ASB-993

SERVICE BULLETIN

TH-27A/E Low TX Power

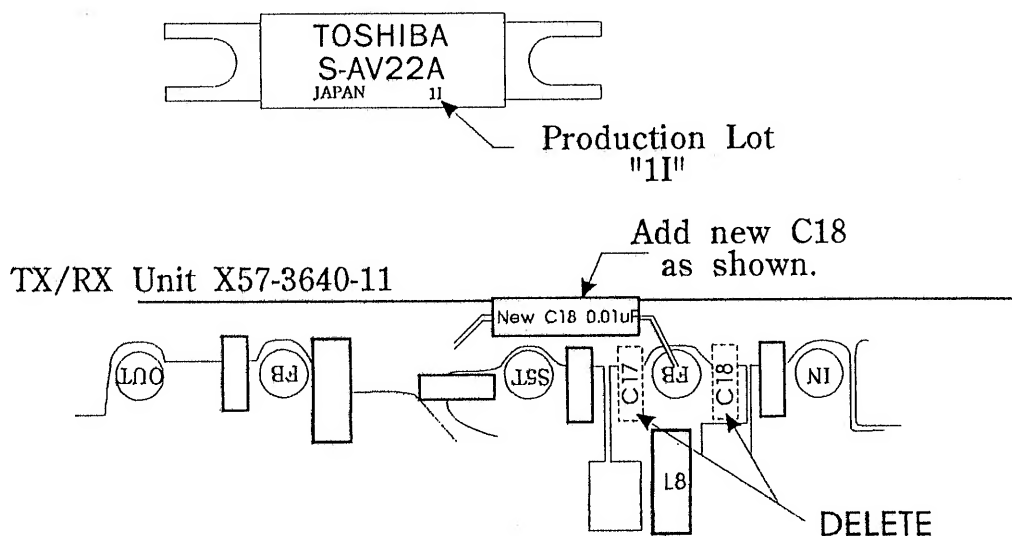
We have noticed some variation in the output power provided by Toshiba S-AV22A power modules with a production code of "11". Modules with this production code might exhibit low or no transmitter output power. This procedure will correct this problem.

1. Remove chip capacitors C17 and C18 from the TX-RX Unit (X57-3640-11.)
2. Install the new axial lead capacitor as shown in the accompanying diagram.

Note: Deleting C17 and C18 alone will not correct this symptom. The new C18 will be used to stabilize circuit performance. Deleting C17 alone will not cure the symptom.
